Approval No.: 19897/2021/MCU

Eden Academy Brassall
102-104 Pine Mountain Road, Brassall Q
Client
Griffith Group

Elevations

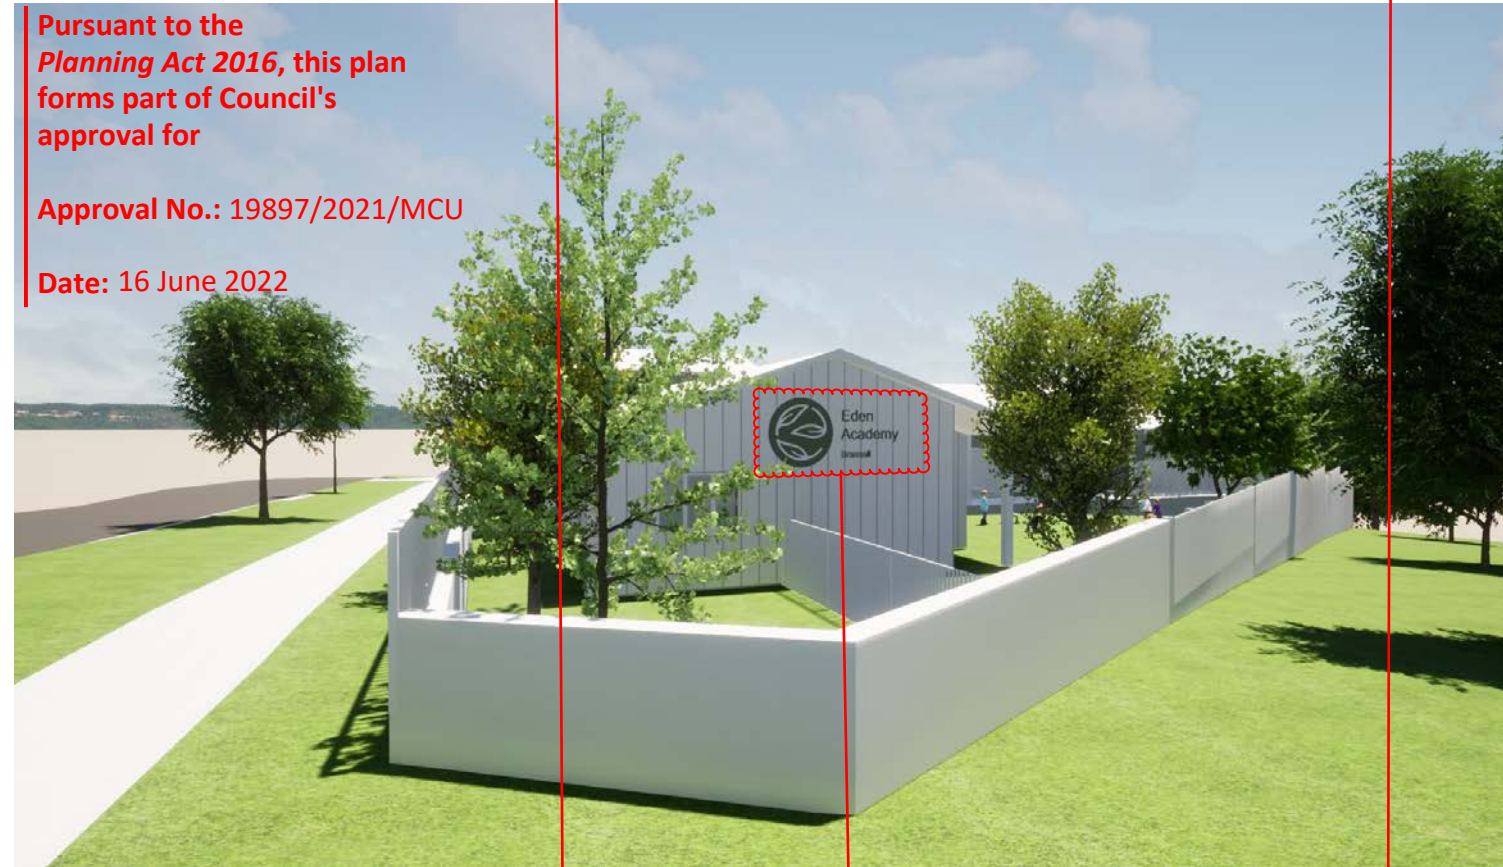
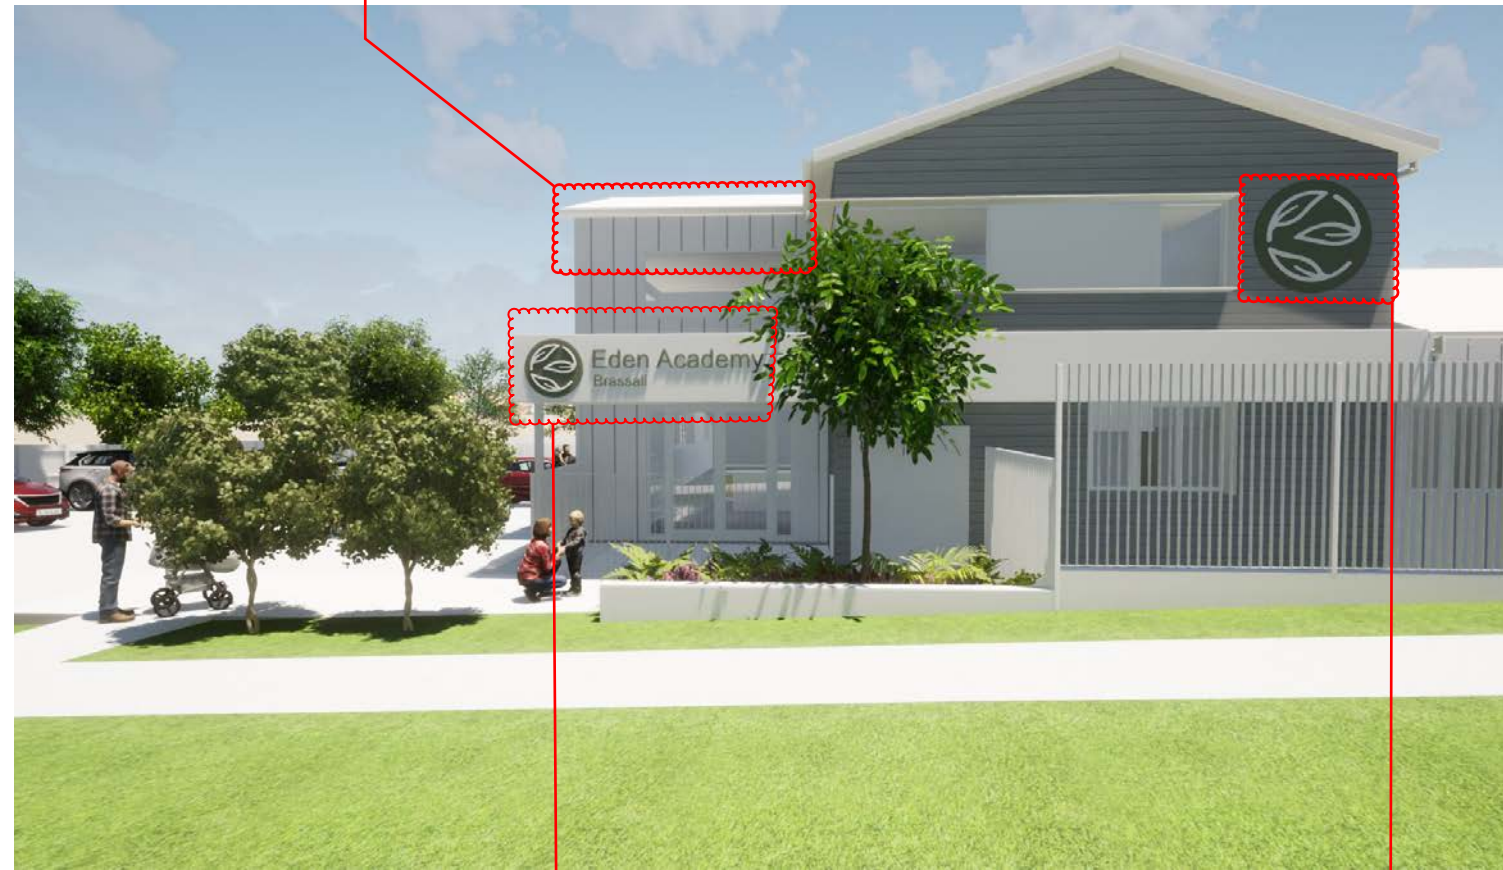
Revised plans to be submitted removing double height void space and establishing a roof line consistent with the rest of the building.

Signage not approved as part of 19897/2021/MCU.

Revised plans to be submitted removing double height void space and establishing a roof line consistent with the rest of the building.

Signage not approved as part of 19897/2021/MCU
